FURCO
Company

QUALITY ASSURANCE
PROGRAM

REPORT NO E-77-32

PLANT: Midland UNIT 1 &
SUBJECT OF AUDIT: Soil Placement
Records

Attachment A: Partial Plan of Northeast Dike Showing Test Location

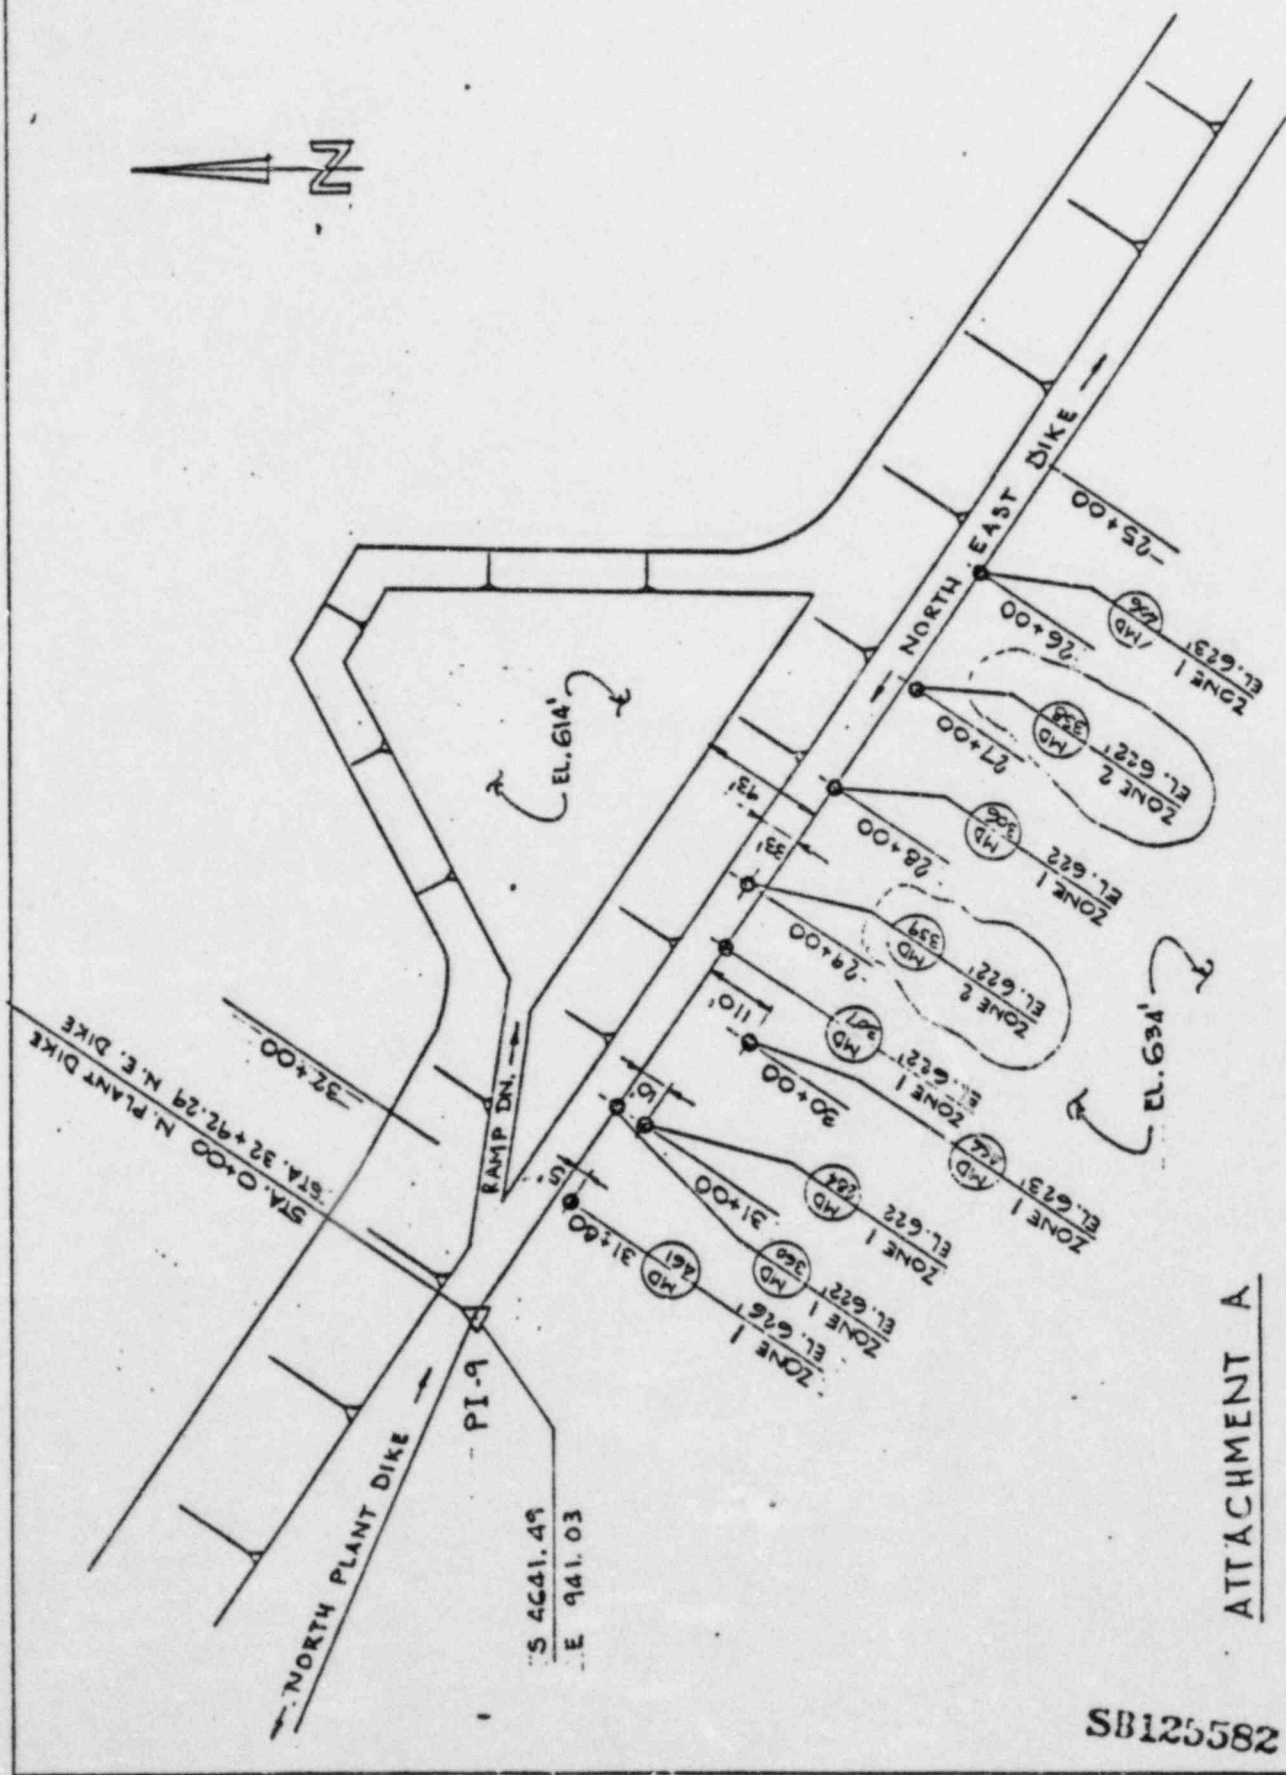
2. The location of MD115 is 50 feet left or west of the dike centerline at station 5+00. Section T, Drawing C-119 and Section K, Drawing C-117 are identical on the plant side (i.e., west side) of the fill. Therefore, test MD115 is shown in a zone 2 area, based on either Section T, Drawing C-119 or Section K, Drawing C-117.

Apparently our earlier evaluation of test MD358, 359, and 440 was not understood. The earlier evaluation noted that there may "... have been an error in identifying the location of the test MD358 and MD440." Consumers also has recognized such a possibility in their similar questions about NCR QF 172. It is agreed that there

are discrepancies in the soils test reports, wherein the test location and soil types listed in the reports are not always consistent with the design drawing dike cross-sections (e.g. zone 2 material listed as material used where zone 1 material should have been used). However, we have reviewed reports for adjacent tests in the same vicinity of test MD358, 359, and 440; again we conclude that the zone 2 material in a zone 1 area should be considered an anomaly. (See Attachment A)

Therefore, the request for a Project Engineering evaluation to "determine the acceptability of the dike...." based on speculation about errors in recorded data is not appropriate, nor do we believe warranted in this case. Any Project Engineering evaluation would be based on the same test report information which already has been questioned as anomalous by Consumers; the conclusions would only be as good as the facts used as the basis of the evaluation. Although recognizing that documentation errors will infrequently occur, it is not recommended that each document discrepancy be evaluated as though it were fact. Our office is satisfied that appropriate quality control programs, including Geotech surveillance, should provide adequate confidence in the dike construction and its acceptability.

FLOOR PLAN @ EL. 634'-6"

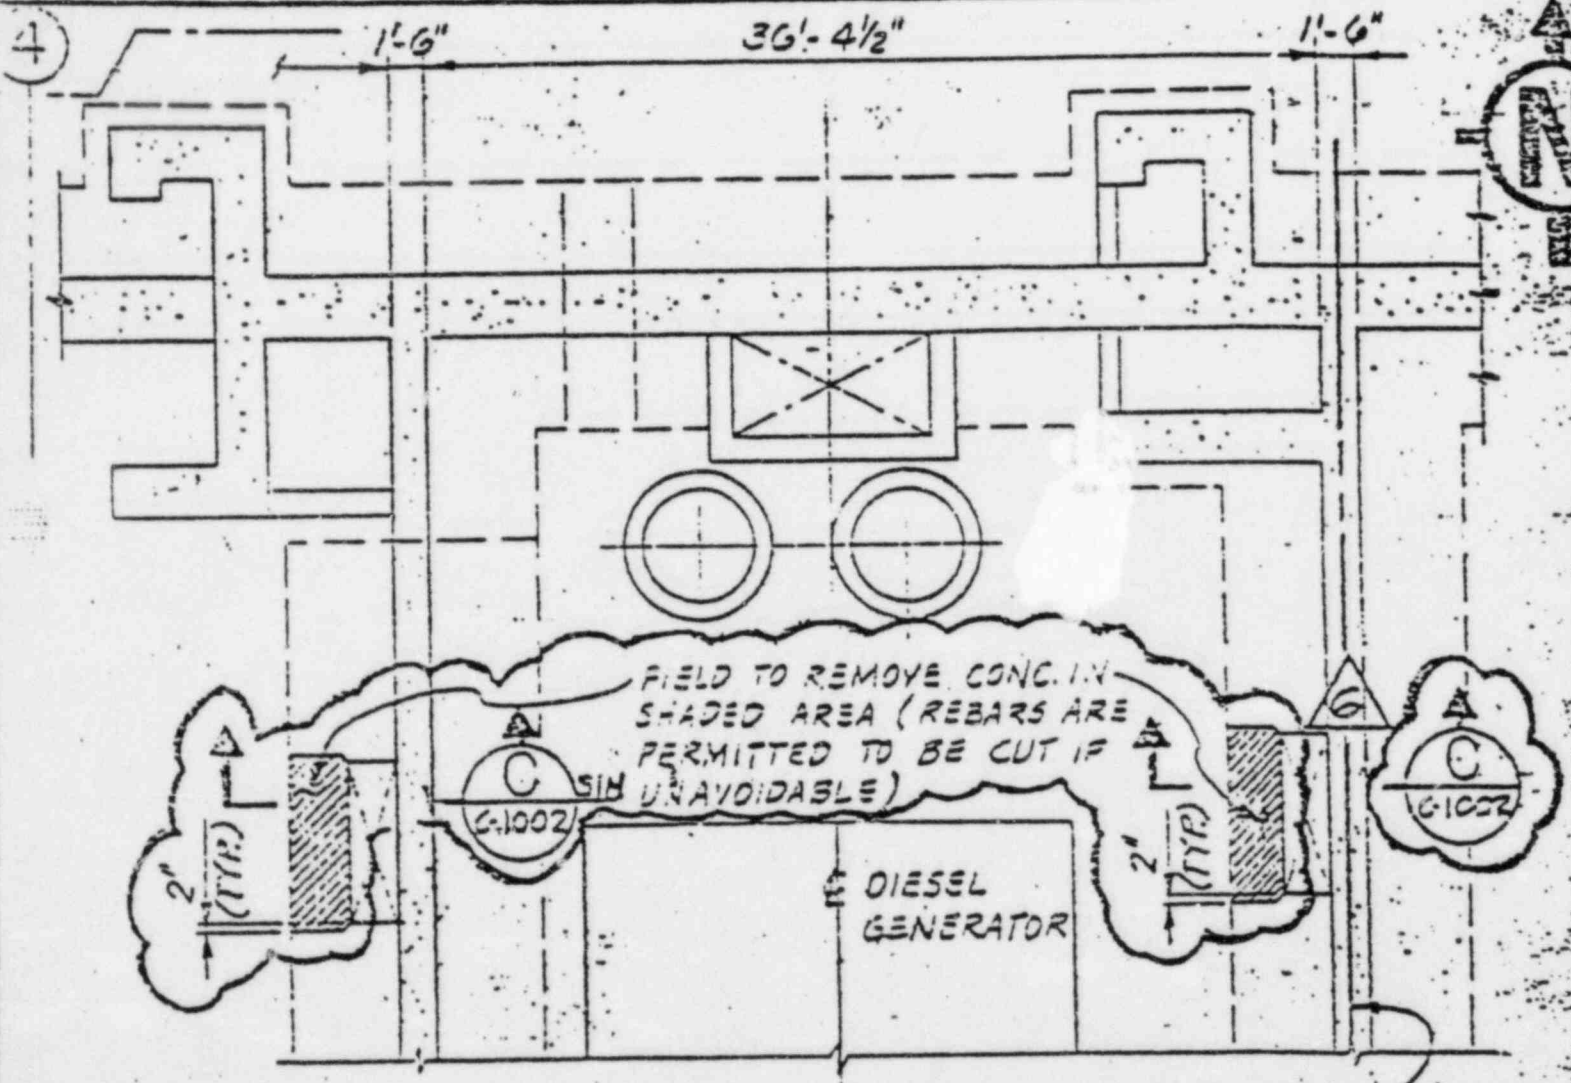
Reason for change: DESIGN MODIFICATION TO ACCOMMODATE PRELOADING REQUIREMENTS

FLOOR PLAN @ EL. 634'-6"

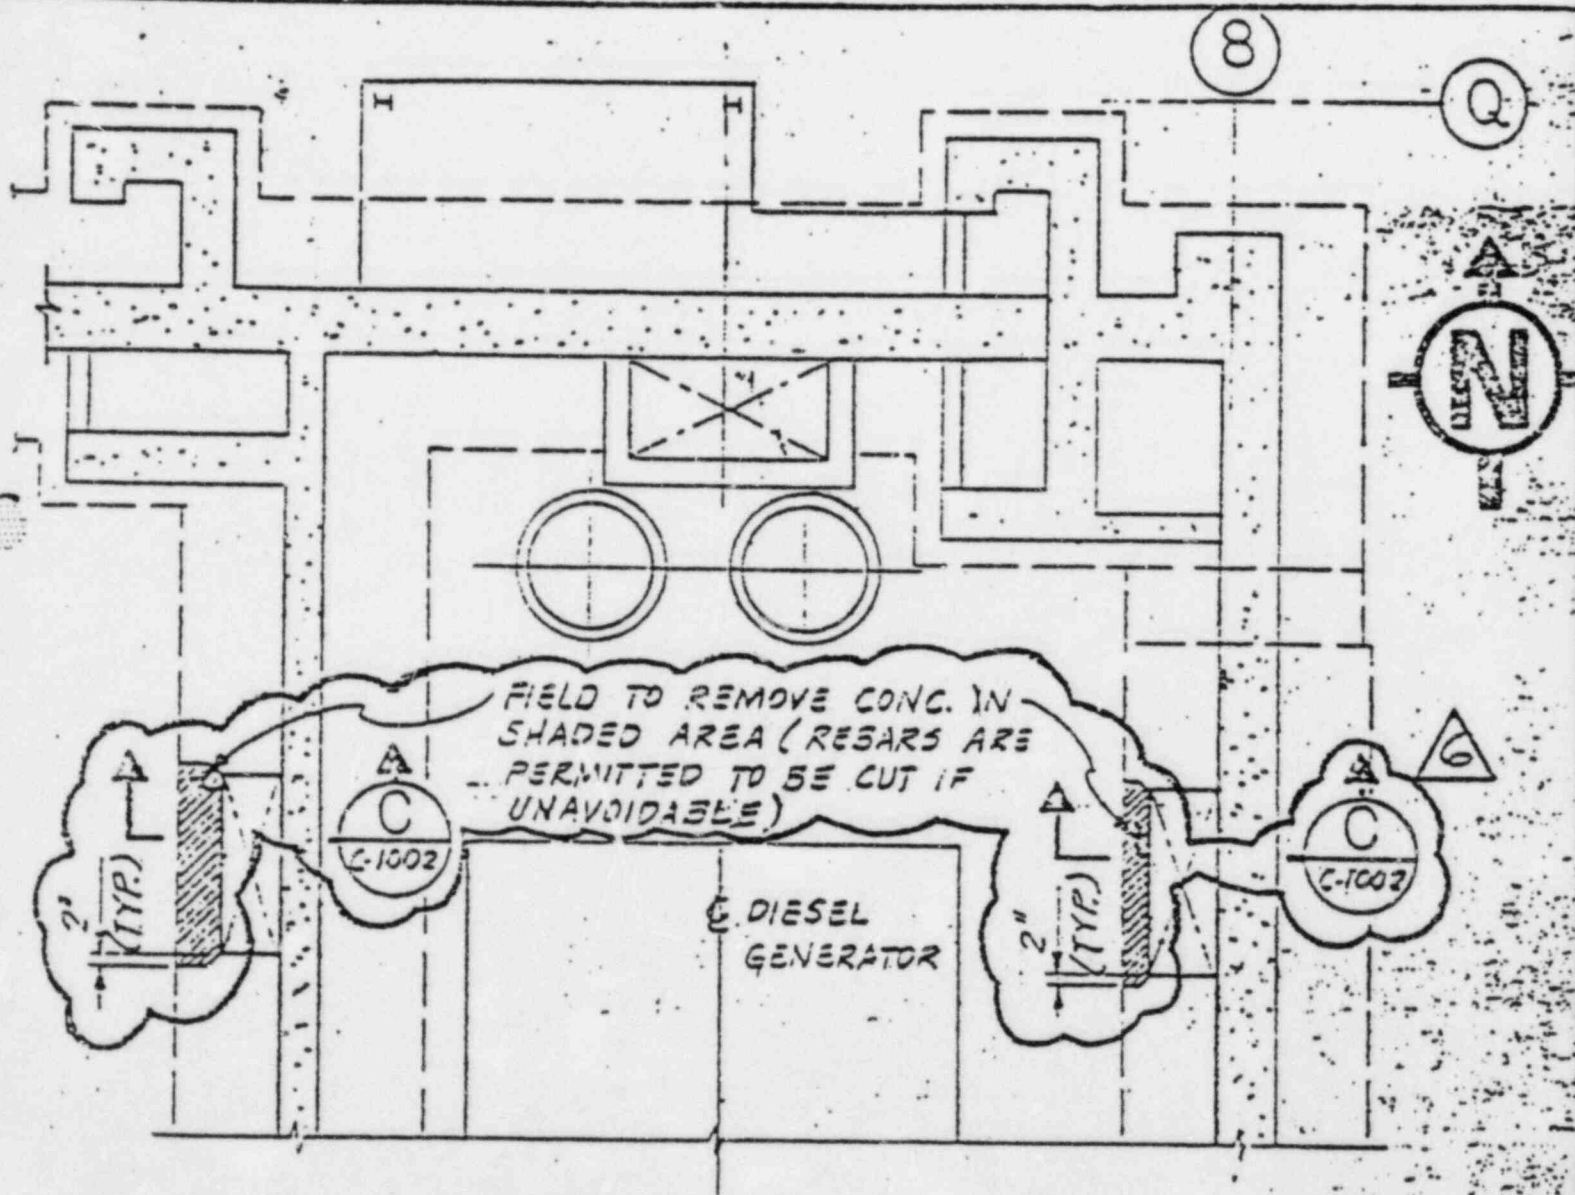
Reason for change: DESIGN MODIFICATION TO ACCOMMODATE PRELOADING REQUIREMENTS

FIGURE 1

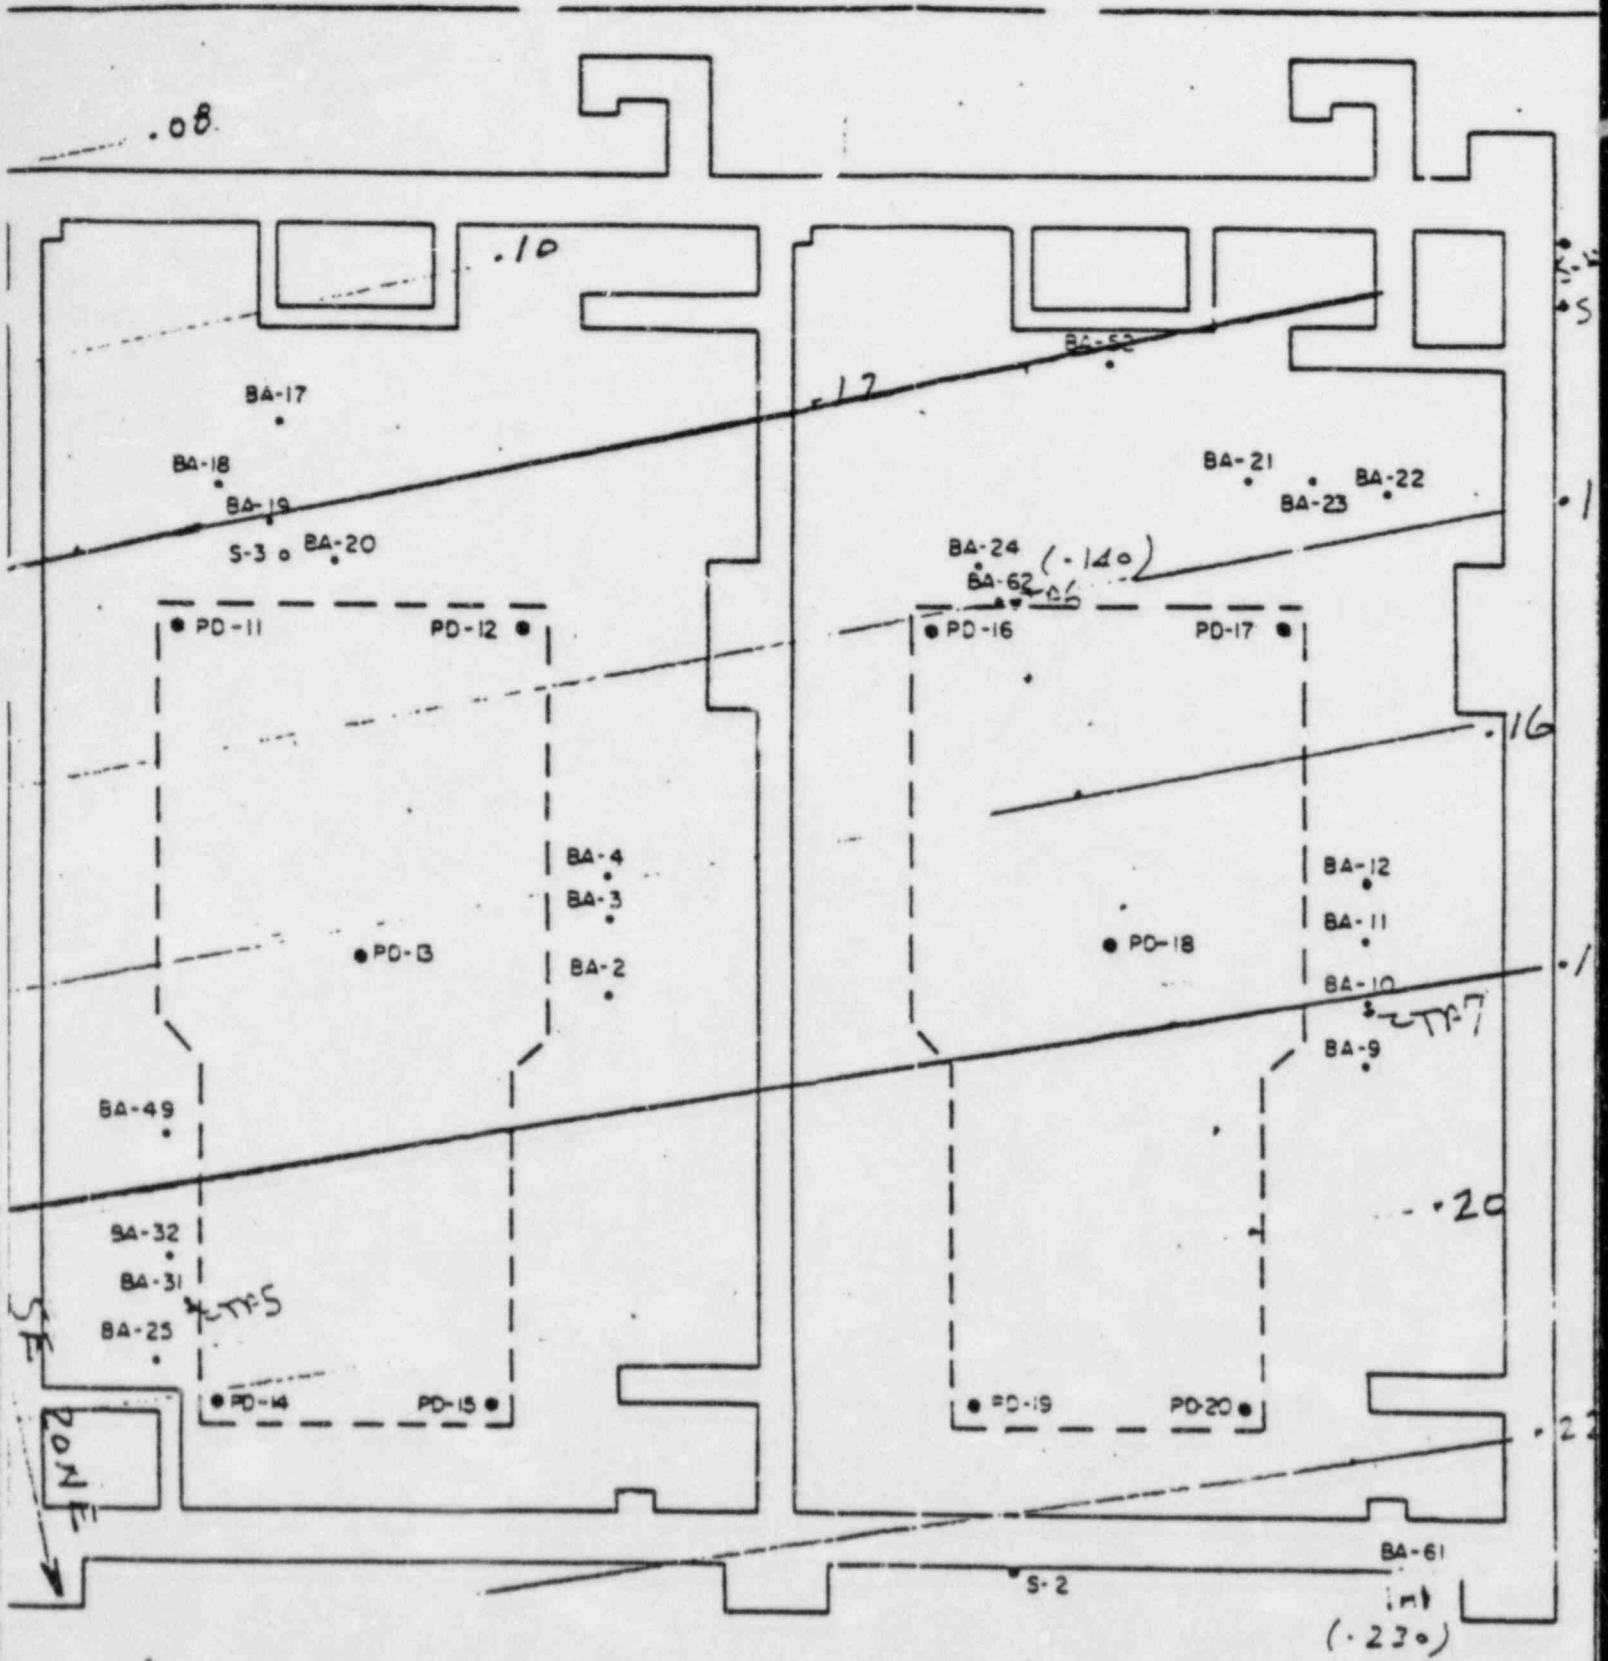
2. I've used Fig. 1 to determine NW and SE absolute settlements for the 60-120 day elapsed time period, and added these to your third sheet from the early June meeting (attached Fig. 5). Settlement rates appear consistent. This fact supports the contention that BA 61 through 64 data are absolute settlements, i.e. that elev. 535 ft is below the seat of settlement, because your plotted data are referenced to a deep benchmark. Sondex data will give further input to this, as they will include a pattern of vertical movement throughout the foundation above elev. 535 ft.

See comment #3 in letter

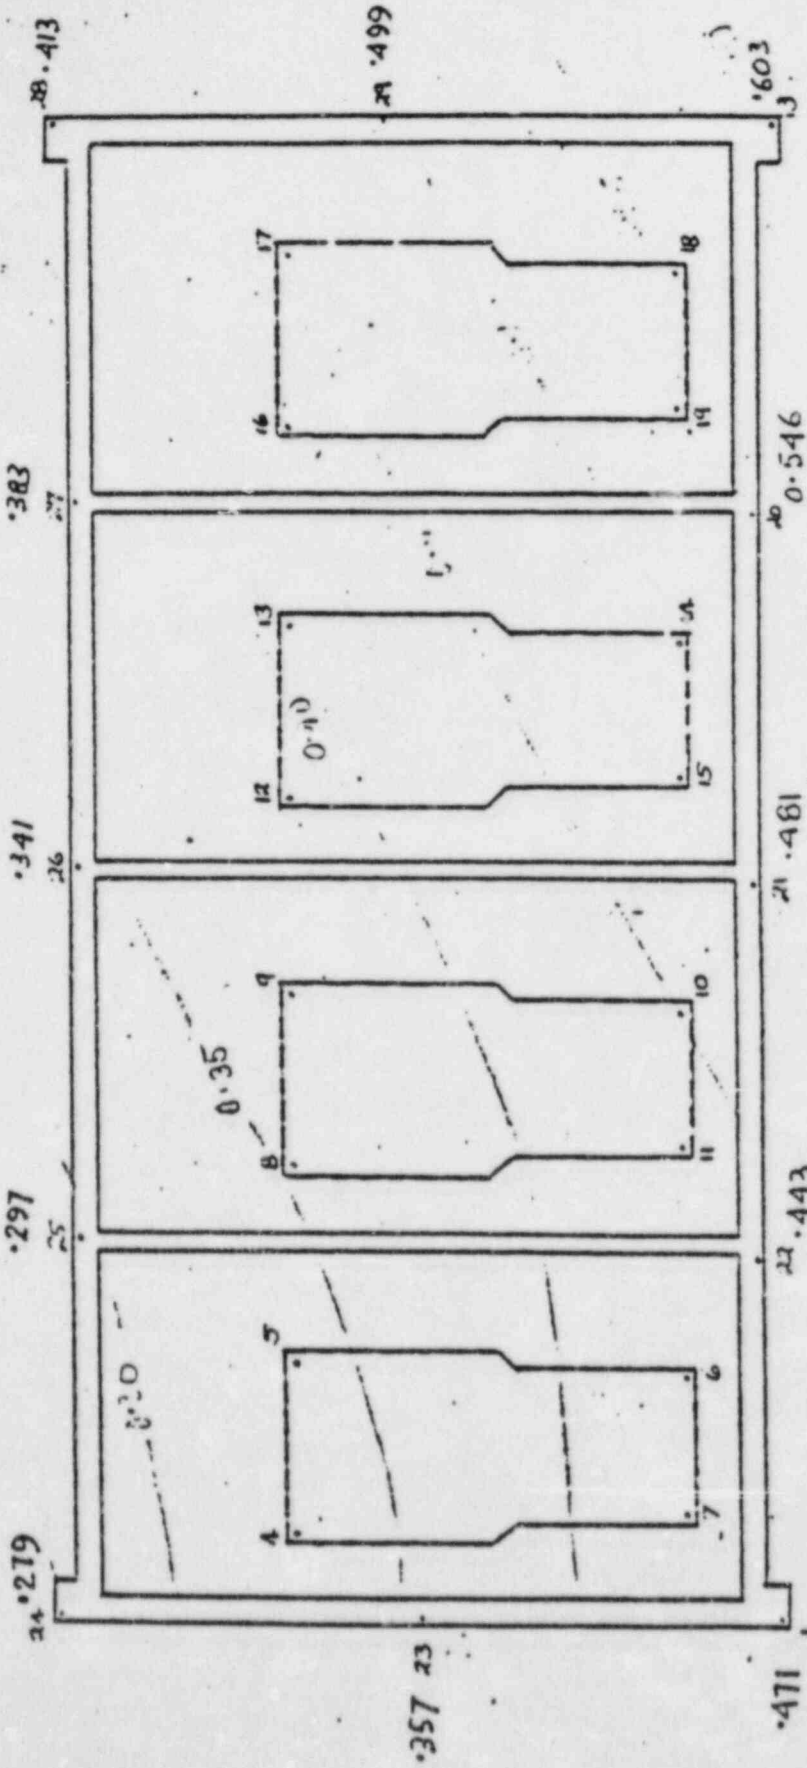
3. Fig. 2 indicates the same type of scatter noted on the optical survey Borros anchor and settlement platform plots (Eleventh sheet of your June meeting handout, here as Fig. 6) and I recommend that you work with these data in cluster groups, as you did to derive the twelfth sheet (Fig. 7). Fig. 2 shows, as it should, generally lesser settlement with depth and generally lesser settlement towards the NW zone. It also shows continuing settlement below elev. 585 ft. I believe it is realistic to add the four BA 61 through 64 points (0.230, 0.195, 0.140, 0.095 inches) on Fig. 2 at the elevation of the bottom of the footings (628 ft ?), i.e. to assume no significant length change between footings and mezzanine floor.
